MICROLIGHT AIRWORTHINESS APPROVAL NOTE

MAAN NO: 2013

TITLE: Microlight Airworthiness Approval Note 2013, Savannah – Service Bulletin 2013: modification of rear cross-member

<i>Title: UK Savannah: Inspection of rear cross-member</i>	
<i>Reference: SB BMAA MAAN 2013 issue 4</i>	<i>Applicability: UK Savannah aircraft</i>
<i>Issue date: 26 March 2007</i>	
Mandatory inspections and modification.	
This SB must be actioned BEFORE FURTHER FLIGHT.

Figure 1

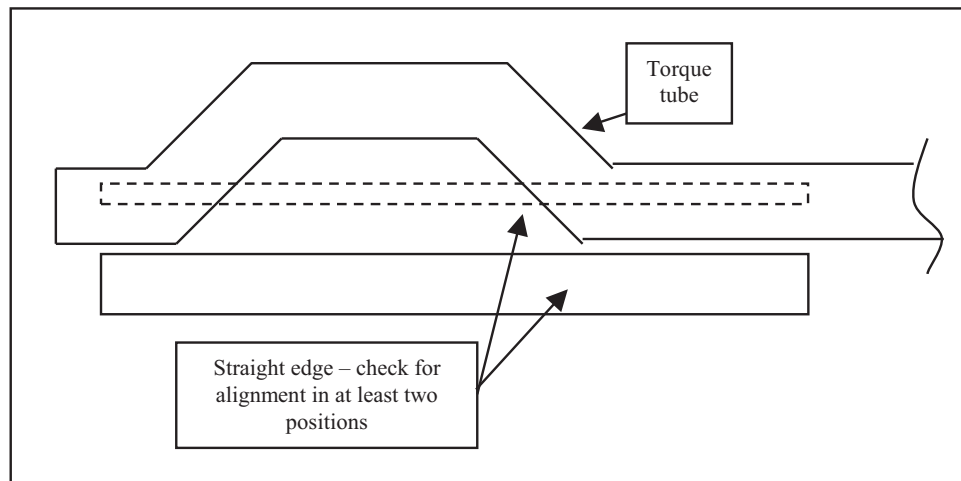
1. Gain access to the cross-member area by removing the rear-fuselage inspection panel.
2. Thoroughly inspect the part SF054 for defects as described above. If any defects are found, the part must be replaced with a new part to be supplied by Sandtoft Ultralight Partnership prior to installing this modification.
3. Inspect the control column torque tube in situ for straightness using a straight edge placed along the length of the torque tube: the sections either side of the crank on which the elevator controls mount must be in alignment. Check in at least two positions at approximately 90° to each other (see figure 1). If the torque tube is found to be out of true (greater than 1mm over the distance of the crank), this must be replaced with a new part to be supplied by Sandtoft Ultralight Partnership.

Figure 6: General location

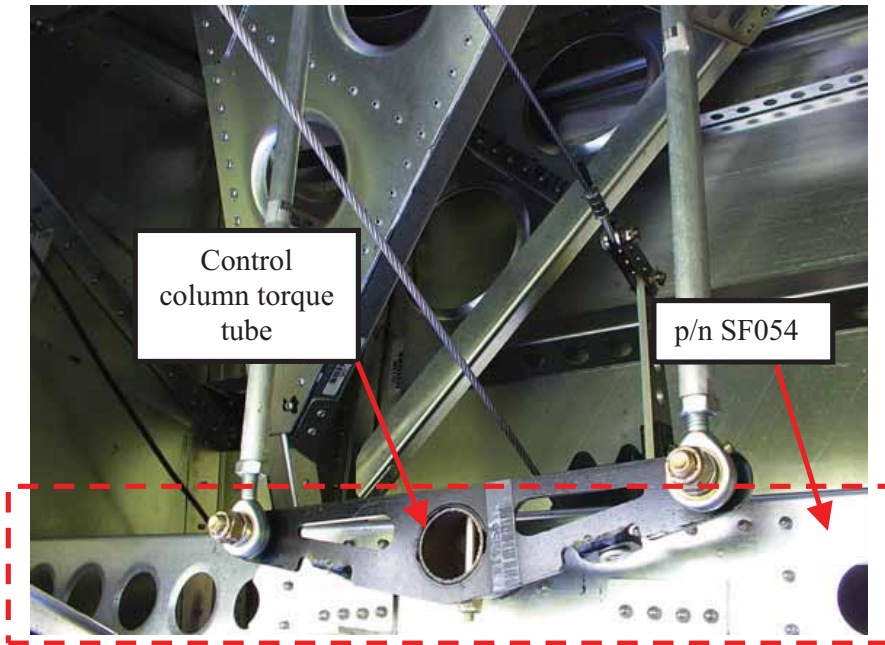
The area to inspect is accessed through the panel in the lower rear fuselage section, just aft of the cockpit. The pecked box in the above photograph highlights the cross-member SF054.

Figure 7: Areas to check

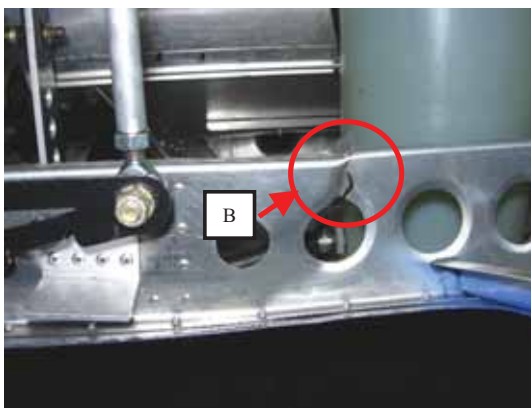
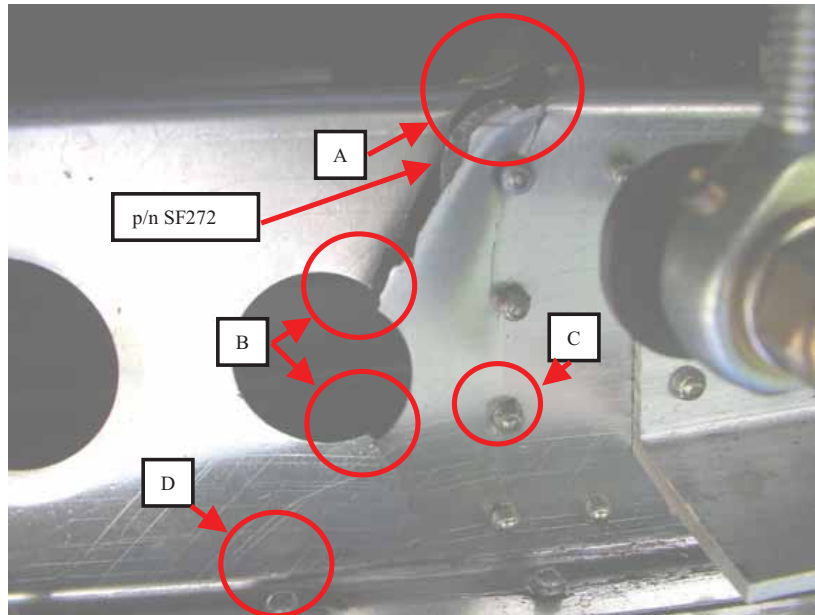
The following areas should be checked (note that the whole beam should be checked, not just in the region of the lightening holes):

A: The top flange. Check for any bends, buckling or cracks. The flange should be flat all the way across. Check for cracks on the inside (forward face) of the bend radius.

B: The lightening holes. Check for cracks anywhere around the edge of each hole (note that all holes should be checked on each side of the aircraft).

C: The rivets. Check for cracks emanating from the rivet holes, particularly where the reinforcement plate SF272 attaches. Check that the heads of the rivets are on the aft face (this illustration shows the tail incorrectly positioned on the aft face).

D: The bottom flange: Check for any cracks in the inside bend radius. Check for any cracks emanating from rivet holes.
